MANDATORY BULLETIN
No BO-112/2005 SWIFT S-1

DESIGNATION-TYPE/MODEL: SWIFT S-1

CONCERNS: Control column and stop in elevator control circuit

WORKING INSTRUCTION
INSPECTION OF CONTROL COLUMN
IN ELEVATOR CONTROL SYSTEM
OF SWIFT S-1 GLIDER

picture 2 : Elevator control column

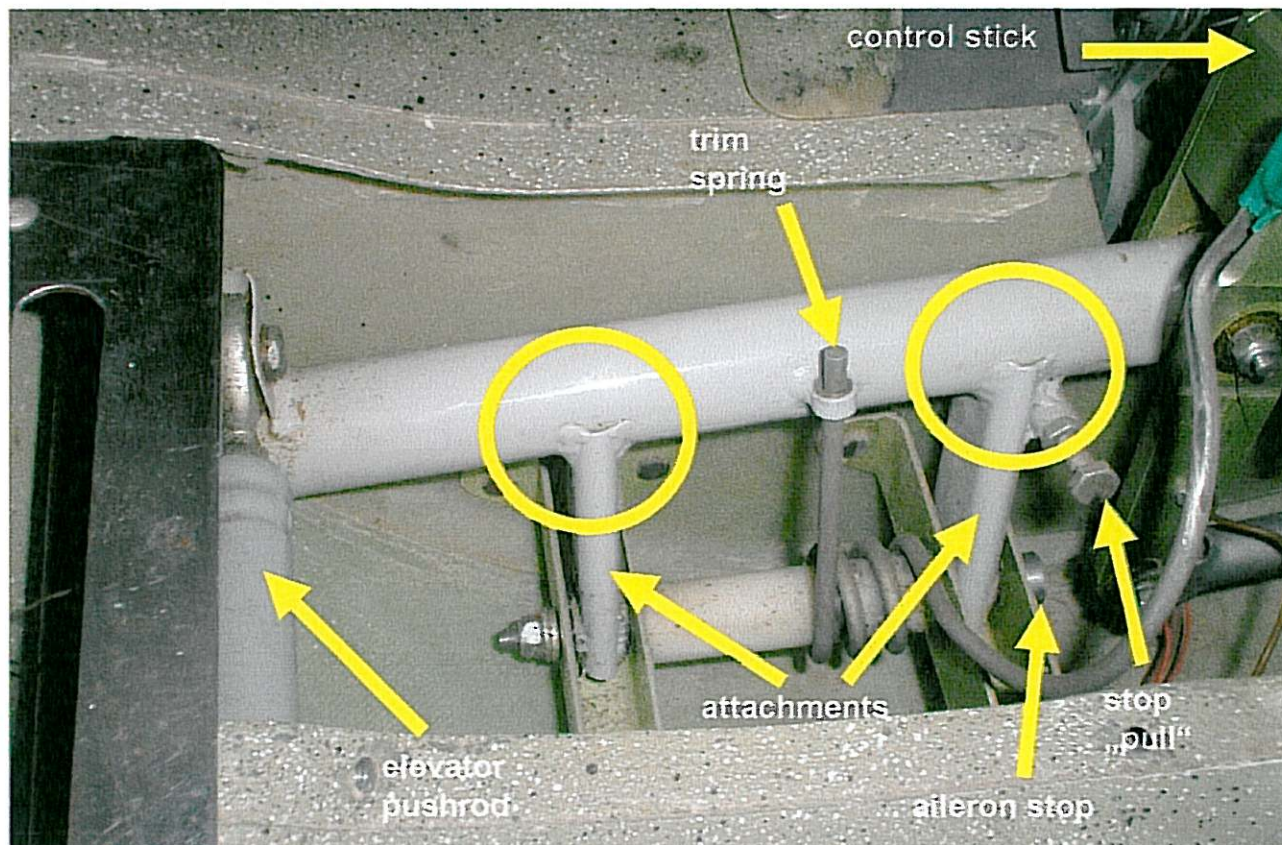
- I) Dismantle the control stick cover and remove the left (in flight direction) access cover of the controls close to the control stick (s. picture 1).
- II) Inspect the welding seams of the attachments (see circles in picture 2) over the whole length for cracks and other damage; use a strong pocket lamp and a mirror - if necessary. If crack or other damage is found, the control column must be replaced.

picture 3: Damage viewed from front

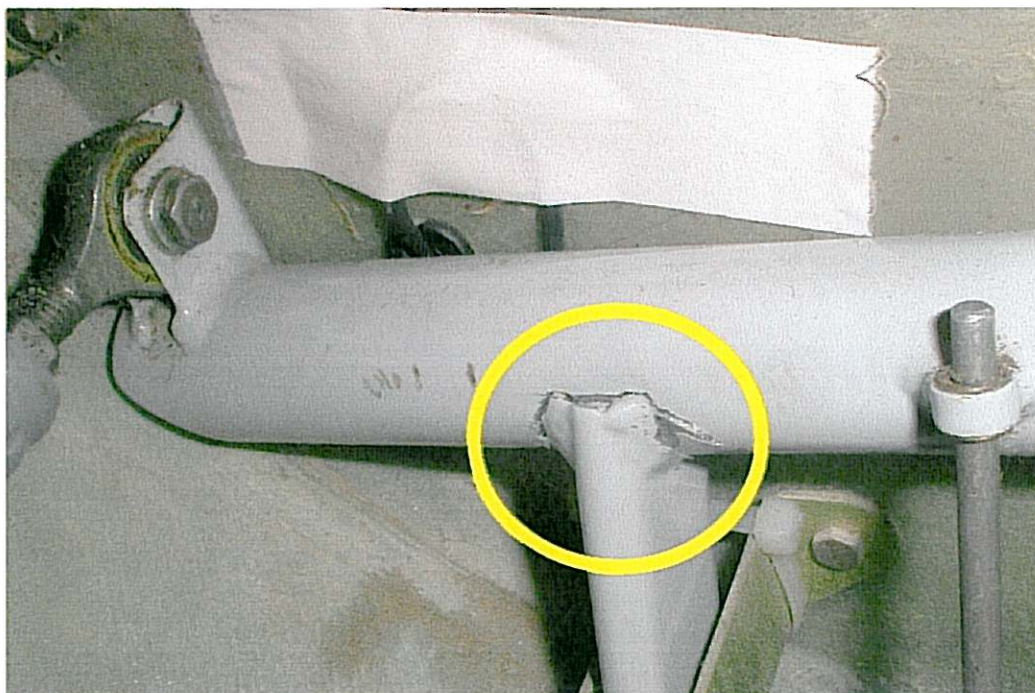
picture 3 and picture 4 show a sample of the possible damage.

picture 5: Check of the stop for elevator „nose down“ (viewed from front)

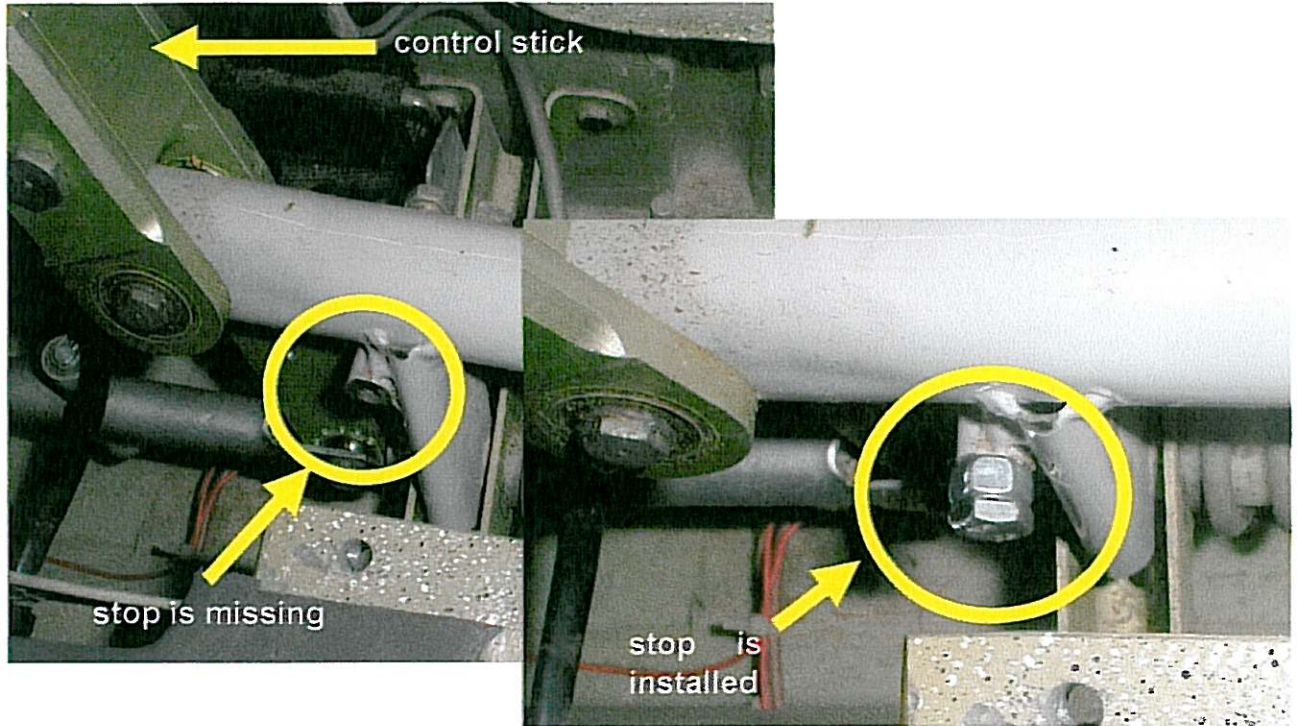
III) Check if a stop is installed on the control column for the „nose down“ (push) position. If no stop (bolt M6) is found, this must be retrofitted according to part 2 of this Working Instruction.

The bolt M6 x 20 must be screwed into the existing thread on the front face of the control column and locked with the nut M6 (see picture 5).

picture 6: Control column pushed fully forward until the stop

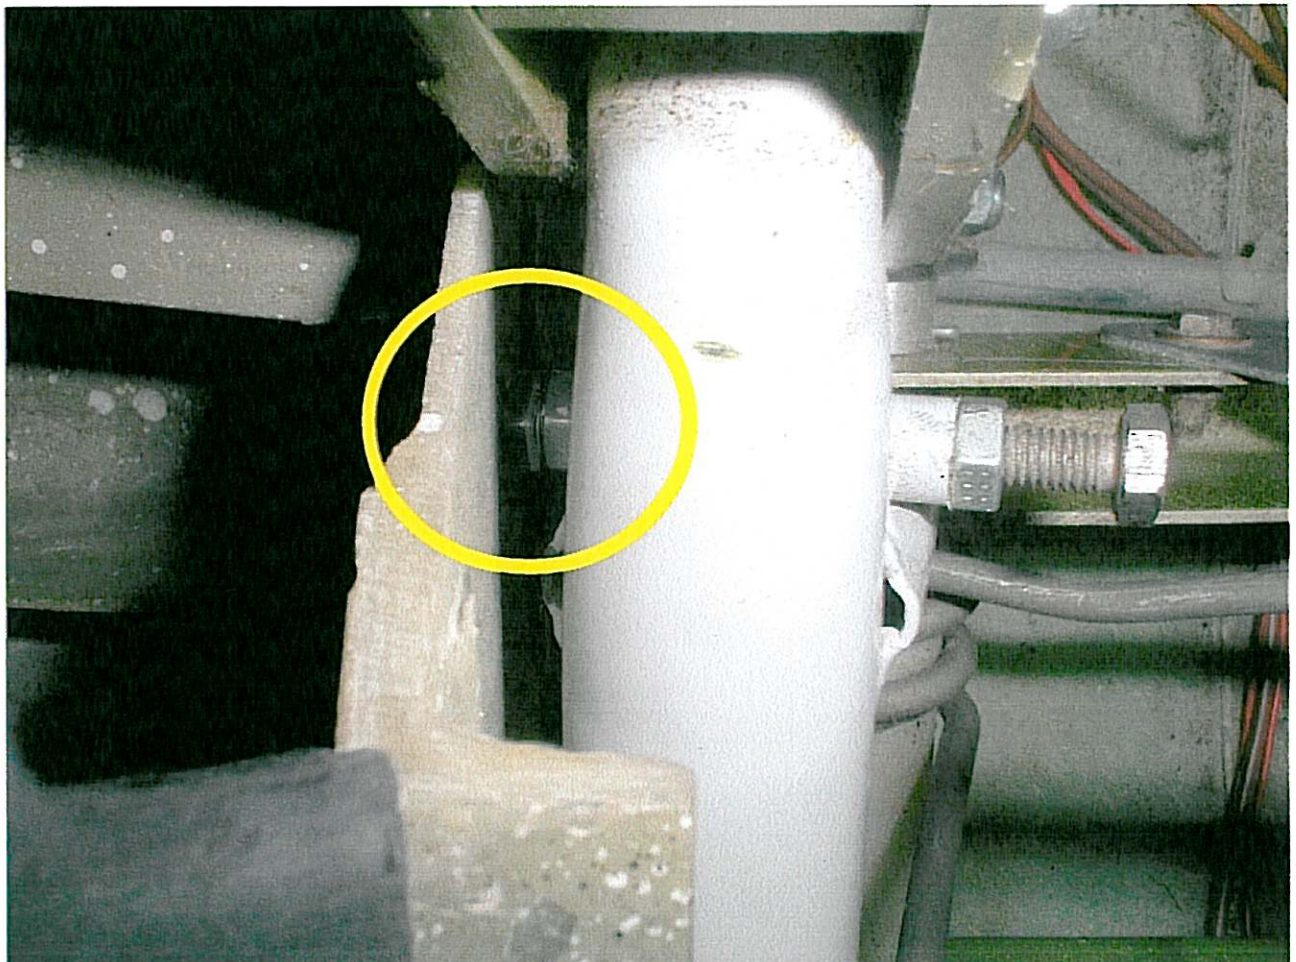
The head of the stop bolt must be adjusted so to hit the front control bulkhead prior to the contact between attachment of the elevator push rod at the outer side (sheet metal-U, see picture 7) and GFRP frame!

picture 7: Swivel-head at the elevator pushrod fixed by a locknut and secured

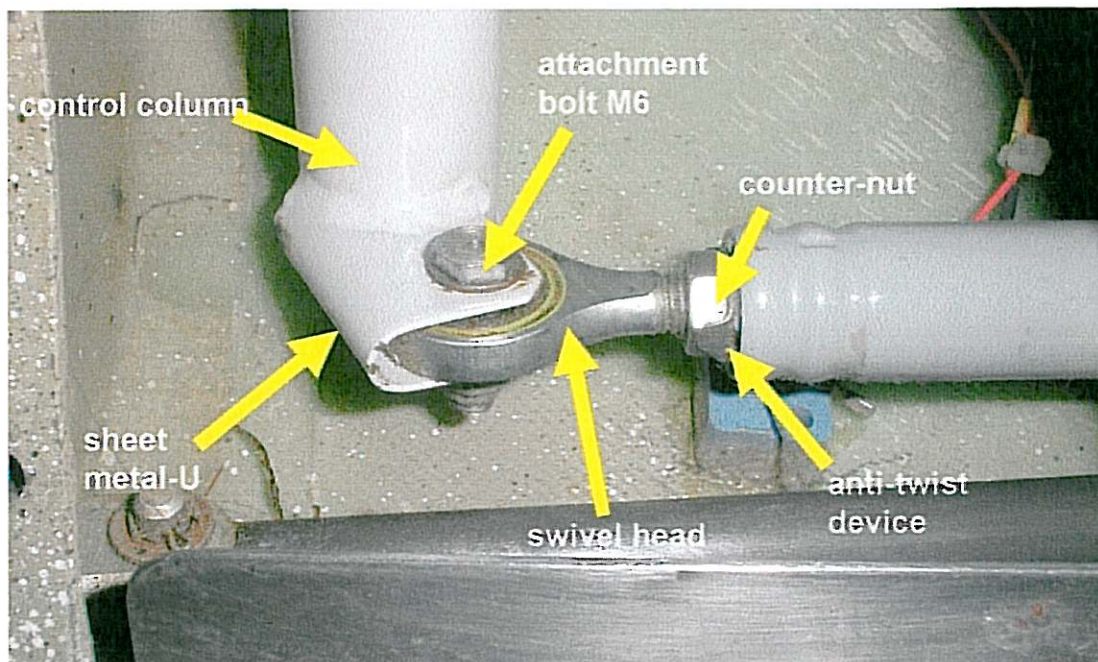
To do so, untighten and disconnect the bolt M6, one connecting the push rod end with the column, mark the positions of the washers and keep all these items. Bend off the anti-twist lock at the counter-nut (sheet metal clip), unthighten the counter-nut and screw the swivel head into the pushrod until the elevator deflections in „nose down“ direction reach the required value (see picture 7 and picture 8).

picture 8: Swivel-head disconnected and counter-nut untightened

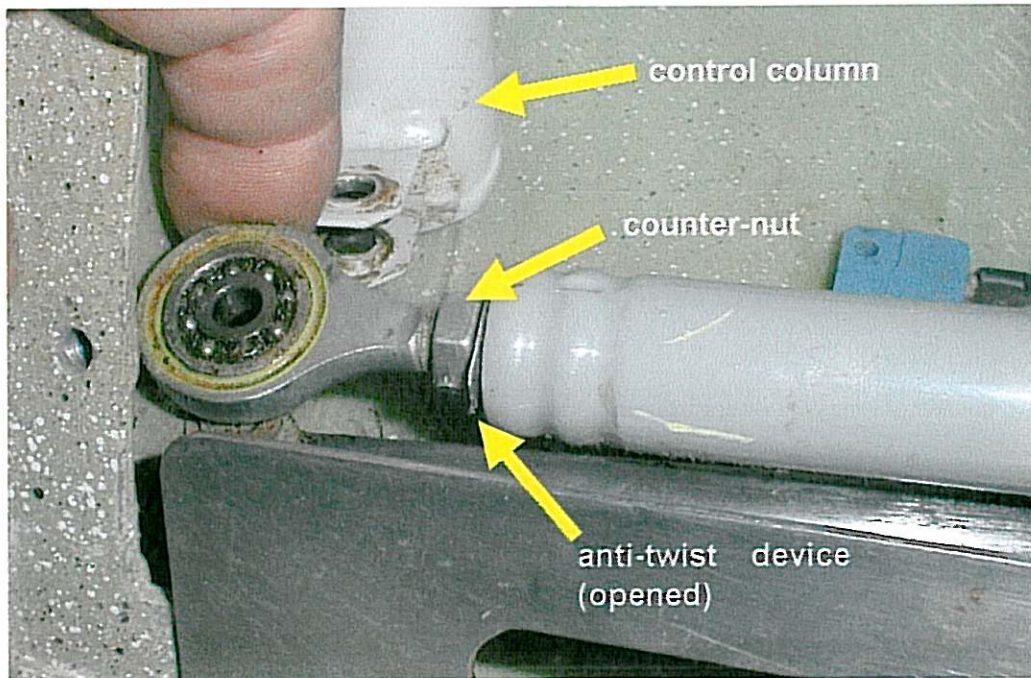
If the swivel-head at the elevator pushrod had to be adjusted, the aft („nose up“) elevator stop has to be readjusted as well.

To do so, untight the counter-nut of that bolt and screw the bolt into the mounting, until the full range of elevator deflection both up and down will be reached, (but not more!) according to the Technical Service Manual. Tighten the counter-nut again afterwards.
